City of El Paso – City Plan Commission Staff Report

Case No: SUSU13-00050 Mesquite Trails Unit Seven
Application Type: Major Final
CPC Hearing Date: July 11, 2013
Staff Planner: Nelson Ortiz, (915) 541-4931, ortiznx@elpasotexas.gov
Location: North of Pellicano and East of Sunfire
Acreage: 22.84 acres
Rep District: 6
Existing Use: Vacant
Existing Zoning: R-3A
Proposed Zoning: R-3A
Nearest Park: Paseo Del Sol Park (.47 mile)
Nearest School: John Drugan Elementary School (0.18 mile)
Park Fees Required: N/A
Impact Fee Area: N/A
Property Owner: Americas Loop 375 Joint Venture
Applicant: Tropicana Development
Representative: CEA Group

MESQUITE TRAILS UNIT SEVEN

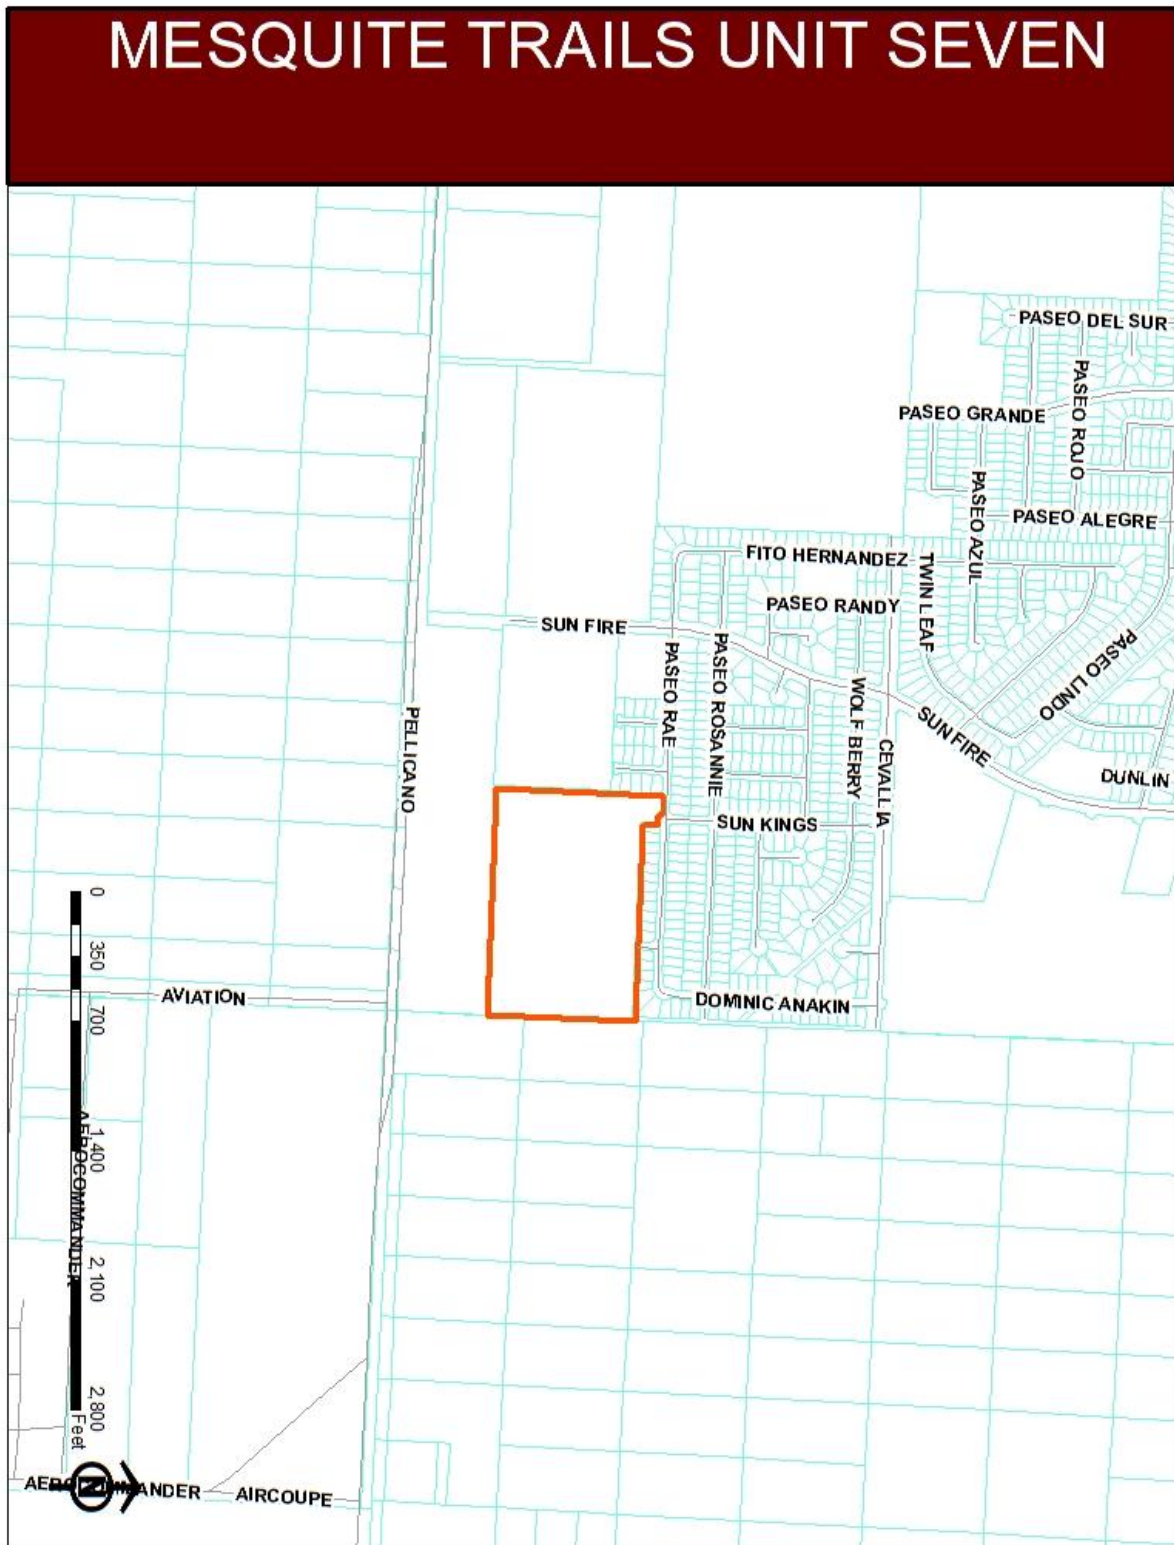
- Requests that **AZULEJOS STREET be divided into two separate streets with two separate street names** because of an address numbering conflict. Efficiency with emergency response is potentially at risk when a single street name has four (4) digit address numbers neighbor with five (5) digit address numbers.

- Please change Block 30 to Block 42
